SAN FRANCISCO PLANNING DEPARTMENT

DATE: June 24, 2015
TO: Historic Preservation Commission
FROM: Rich Sucre, Historic Preservation Technical Specialist, (415) 575-9108
REVIEWED BY: Tim Frye, Preservation Coordinator
RE: **Review and Comment for Downtown Ferry Terminal Expansion
Case No. 2013.0100CRV**

South Basin Ferry Terminal Design Project

HISTORIC PRESERVATION COMMISSION SUBMITTAL

SOUTH BASIN SUMMARY OF PHYSICAL CHANGES, 1915 TO 2010

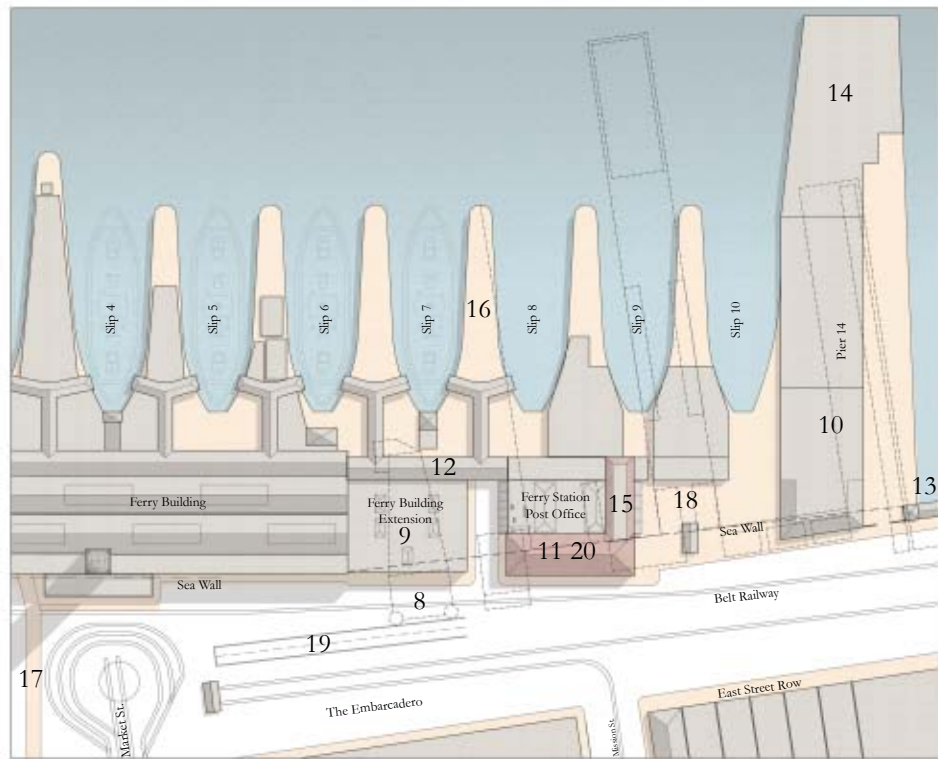
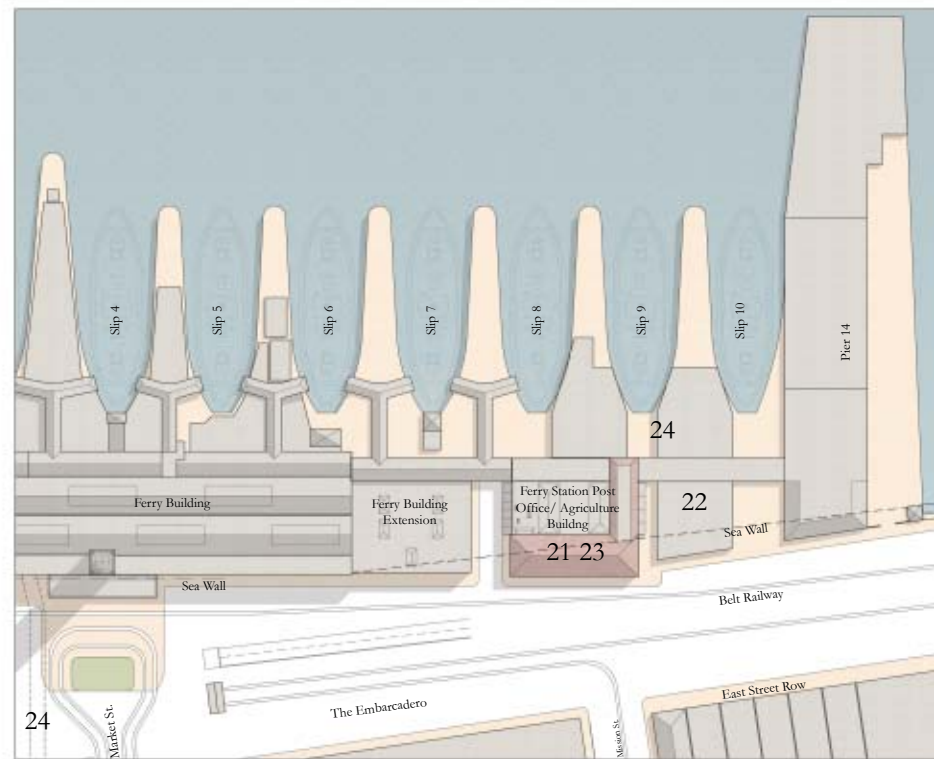
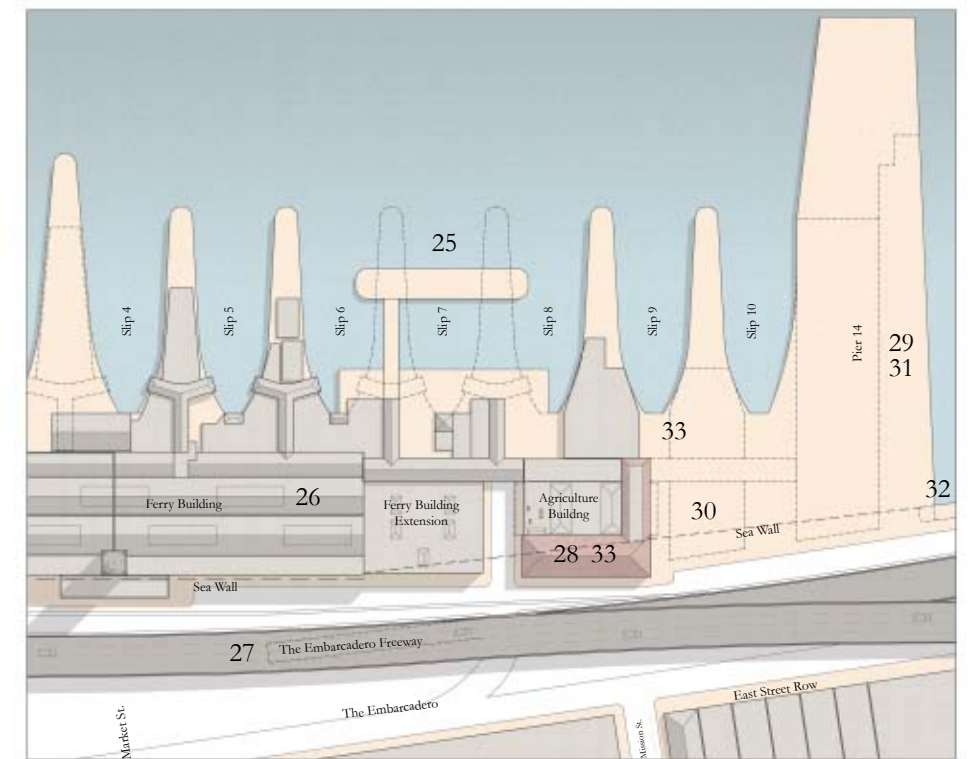
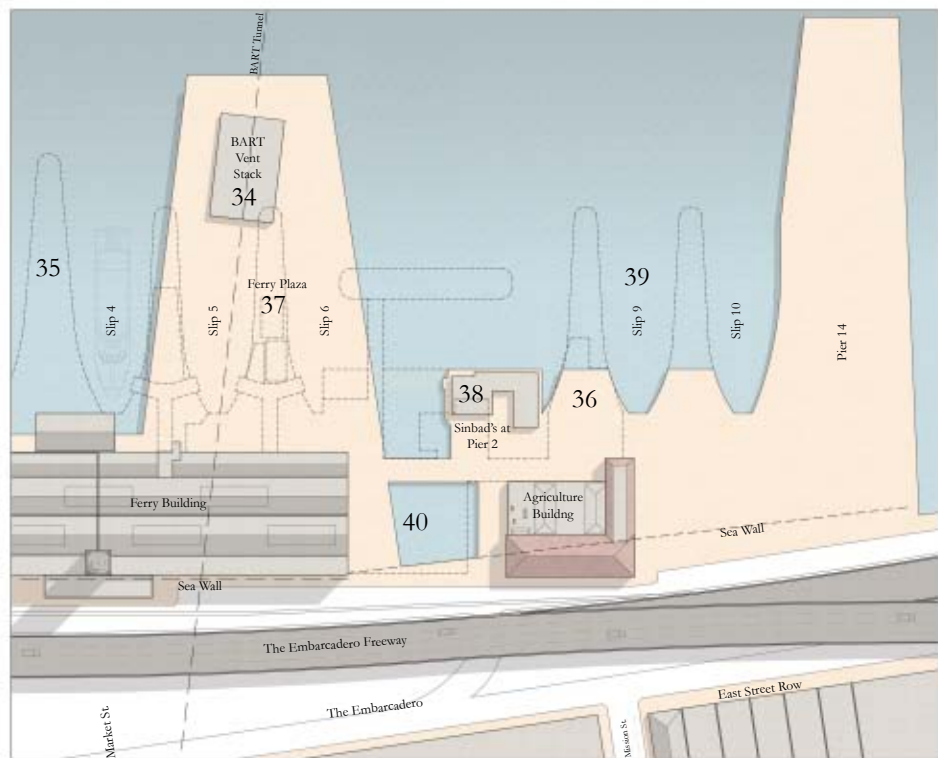
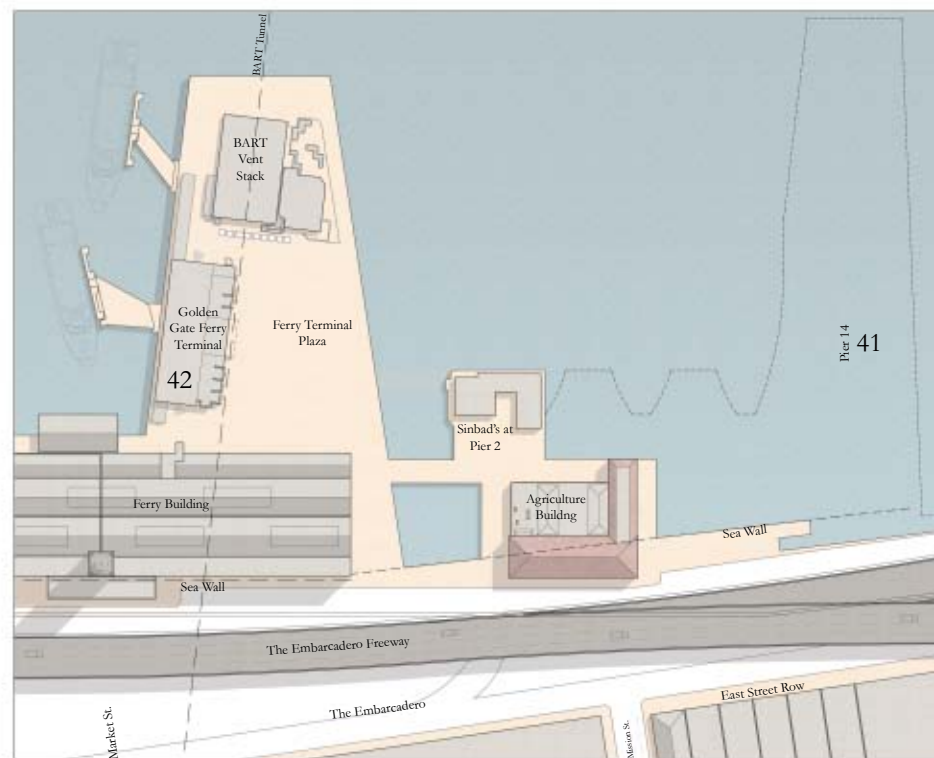
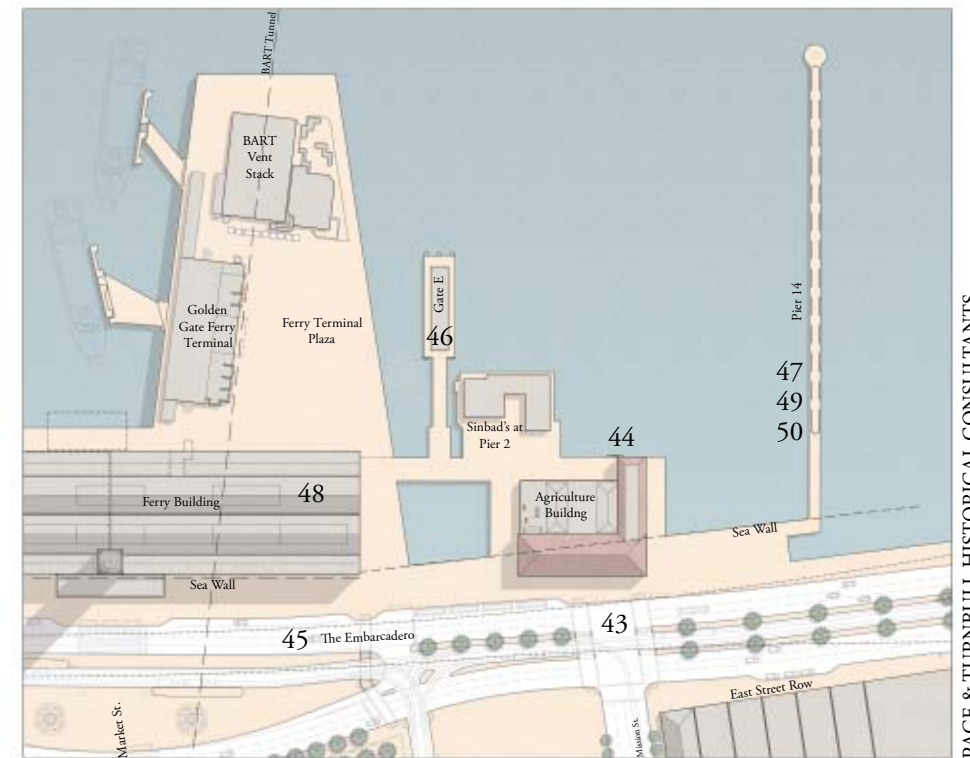
As designed, the Embarcadero Plaza appears to be compatible with the surrounding historic district and adjacent landmark, since this aspect of the project would be restorative in nature. As evidenced by the historical diagrams illustrating the physical changes along the South Basin, this lagoon was once infilled and is the former site of the Ferry Building Extension, which has since been demolished. The infill of the lagoon would assist in restoring a portion of the district back to its historical configuration.

IN PROGRESS REVISED PLAN RESPONDING TO BCDC DRB AND PORT WDAC COMMENTS

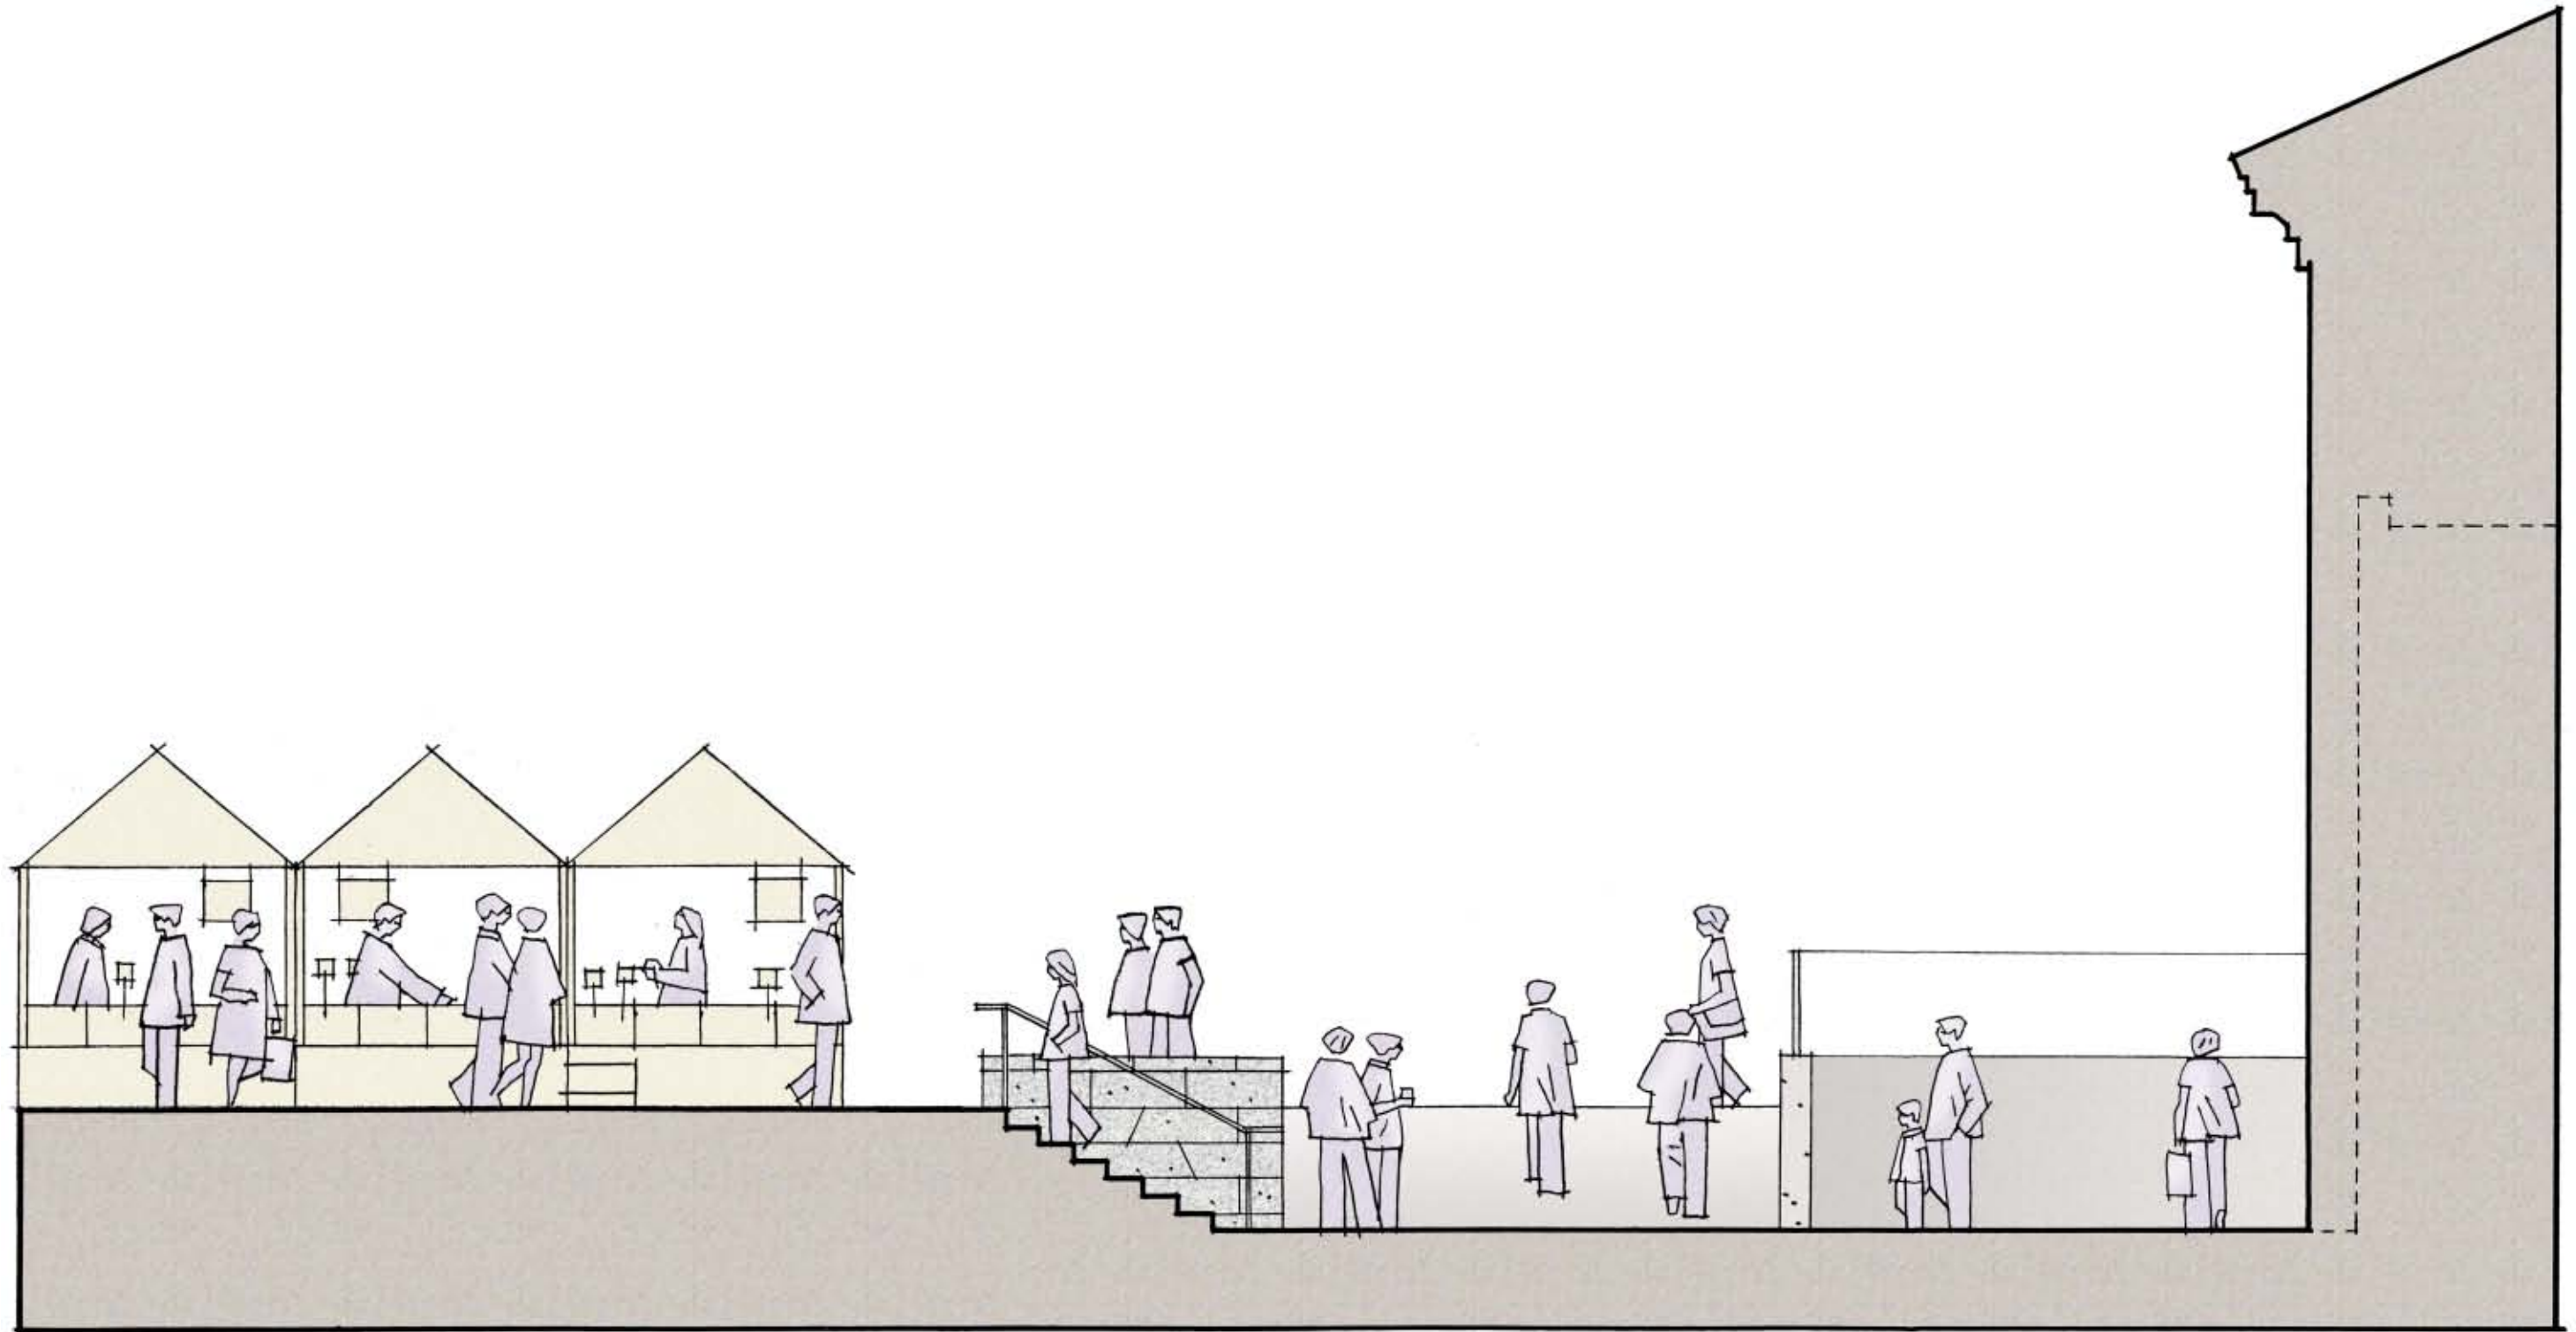
One issue raised by the DRB and WDAC in the joint meeting last May had to do with the relationship of the plaza to the Agriculture Building and the south access to the Ferry Terminal. This has been addressed in the plans which are currently being developed, which reconfigures the geometry of the plaza to be orthogonal on the south and east sides to create a more positive relationship to the Agriculture Building.

PROMENADE PLAN AND ELEVATION OF GATES E, F & G

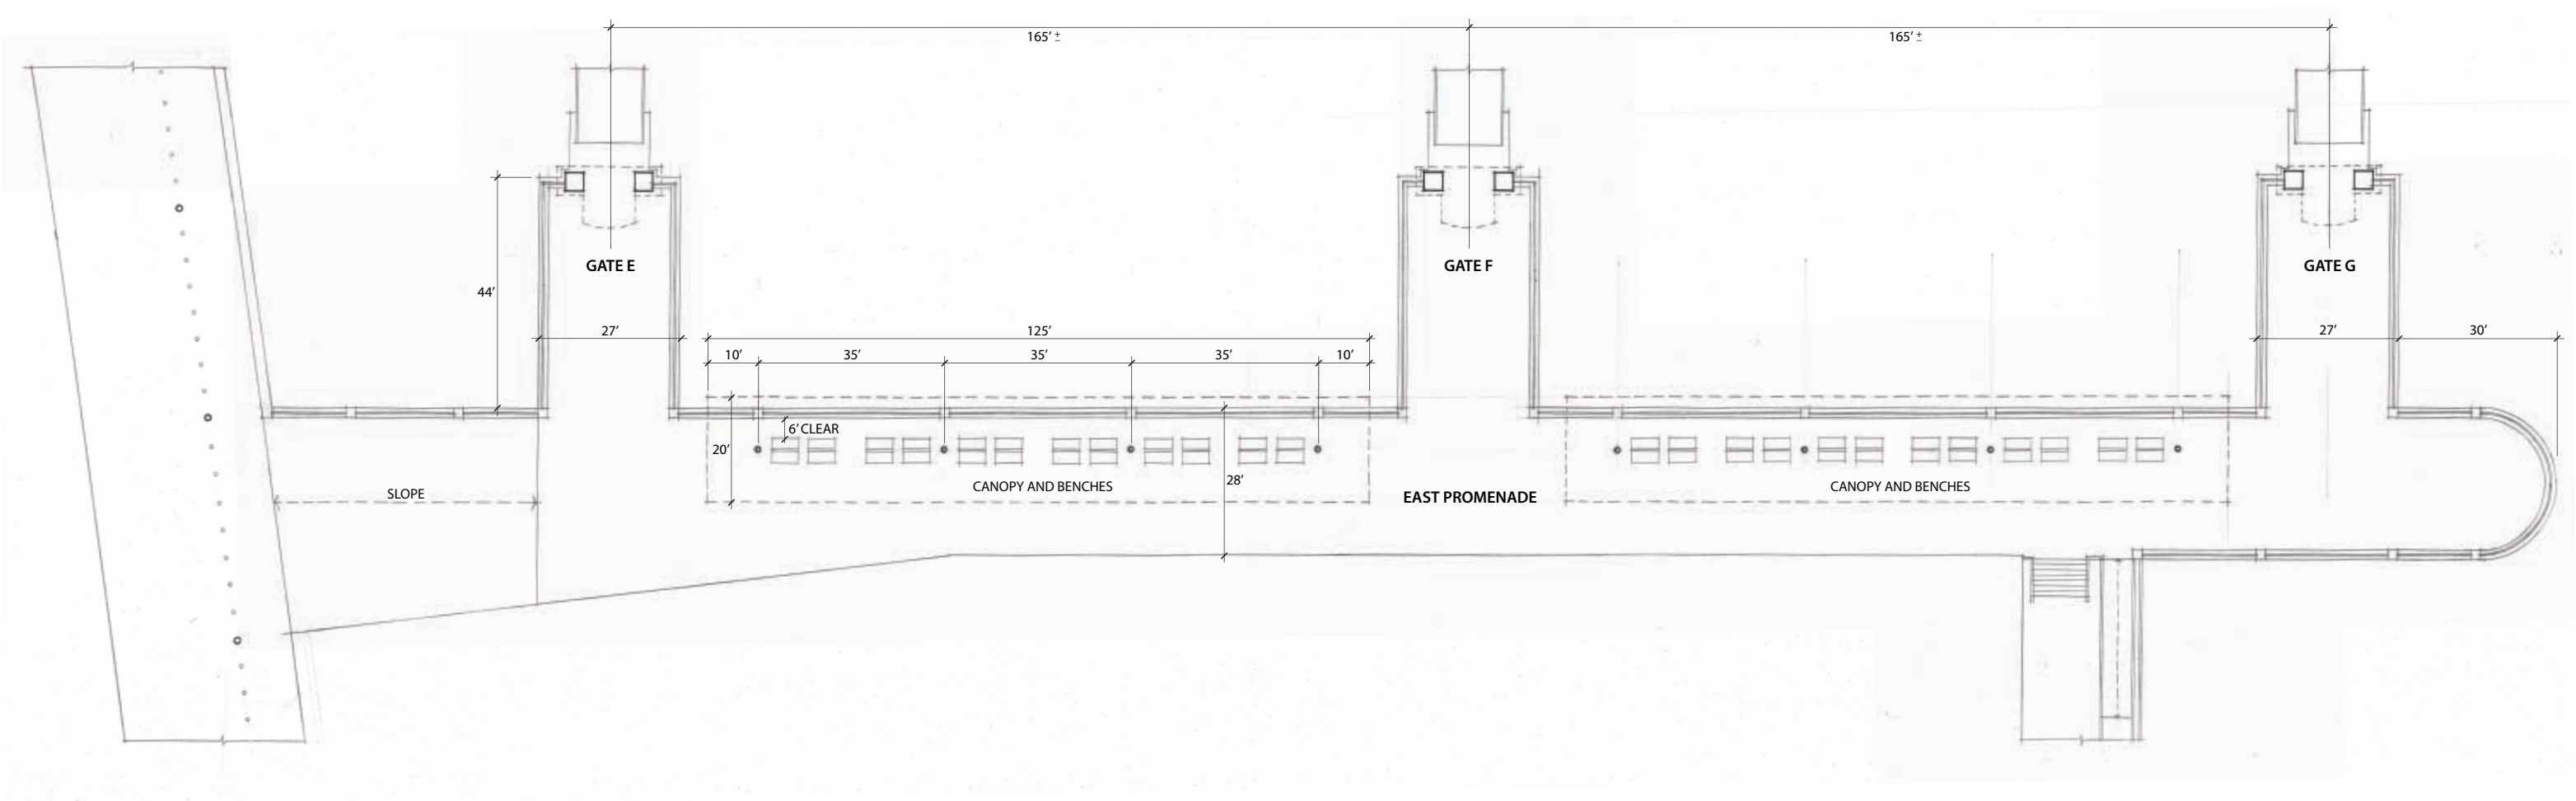
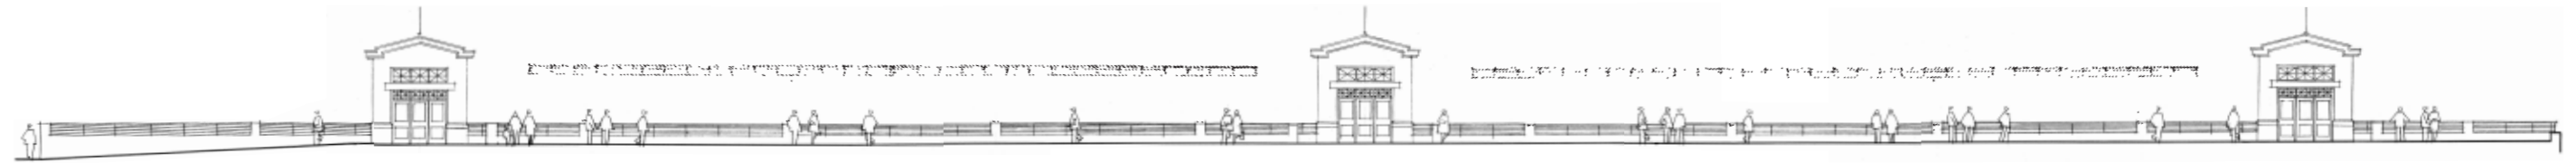
Overall, the Department recommends refining the design of the new photovoltaic canopies to better integrate them with the surrounding historic district and adjacent landmark. The refined design should consider a more slender profile for the new supporting posts and columns, and should provide additional justification for compatibility of the proposed materials with the Ferry Building and Agriculture Building. The Department would also recommend a more solid termination to the canopy edge, rather than a glazed open edge.

In addition, the project analysis would benefit from additional views of the canopies against the east side of the Agricultural Building looking south. These additional views would assist in examining the canopies relative to the surrounding context and Agriculture Building.

Recent revisions propose that the canopy be subdivided into two segments, rather than one continuous length. One segment would be located between Gates E and F and the other between Gates F and G. This approach allows the canopy to still help integrate the three ferry terminals and give a better identity to them while punctuating the gate entrances, creating a greater spatial definition of the edge and more diversity in seating and viewing opportunities.

Each canopy is approximately 20 feet wide and 125 feet long and is designed to allow for a 12-foot high clear height with columns at 35 feet on center. The canopy design has been designed to be as slender as possible with all components made out of powder coated metal and/or stainless steel. The roof of the canopy is semi-transparent with photovoltaic cells laminated in glass, similar to the approach that is used at the Academy of Sciences. The canopy will create a dappled shade minimizing the high contrast effect of a shadow. It is intended to provide rain protection when needed, to organize how queuing and waiting would best be accommodated and create a unity to the three terminals while maintaining an inviting place for public access and general use. The canopies
